**Issuing Entity:**  
**Battech Enterprises, LLC**

**Bulletin # SR-5R-1309-02A**  
**Release Date: September 12, 2013**  
**Effective Date: September 12, 2013**  
**Supersedes: N/A**  
**Completion Date: December 31, 2013**

## SAFETY BULLETIN

Ride Manufacturer: Battech Enterprises, LLC	Affected Production Dates: November 2009-Present
Ride Name: Zero Gravity	Affected Serial #'s: 0911011-5R FORWARD
Model #: All

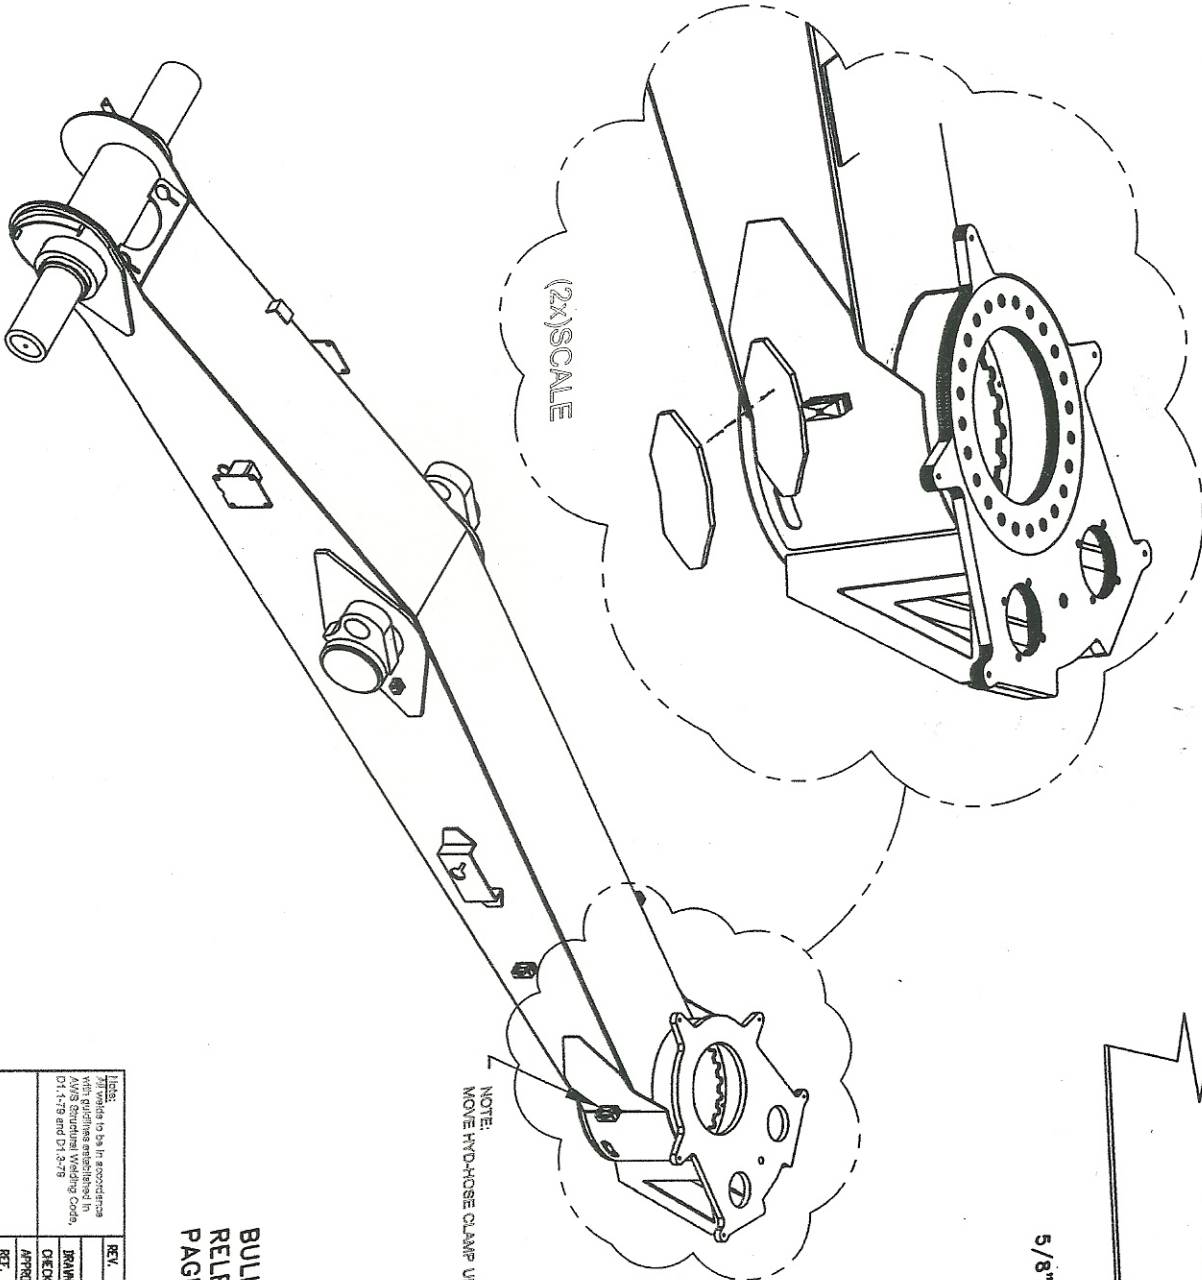
**Abstract of Issue:** Early production Dartron Industries, Inc. Zero Gravity amusement rides were produced using a thinner material on the boom drum and boom reinforcement plates. Cracking has been discovered in this area. Testing has determined that ALL Zero Gravities may eventually develop cracking in the same area.

**Reason for release:** To notify all owners, operators and inspectors of a safety concern with the booms on the Zero Gravity. Subsequent testing has determined that a reinforcement plate is required to insure that this area will not develop cracks at a future time. Failure to add these reinforcement plates may eventually result in the boom drum (bearing base) not adequately supporting the center bearing. A failure in this area could result in injuries.

5. The ground must be connected as close to the weld location as possible to insure that the current does not pass through any bearings
6. Tack securely in place approximately 5/8" from the bottom edge and parallel to it. See the attached illustration on page 4 of this bulletin.

7. Preheat the joint to at least 100 degrees Fahrenheit.
8. Weld the joint with 7018 electrode using DCEP (reverse polarity). Apply stringers in the horizontal and overhead positions. Clean between passes and continue to weld until a 1/2" fillet weld is achieved. **DO NOT WELD THE VERTICAL ENDS.**
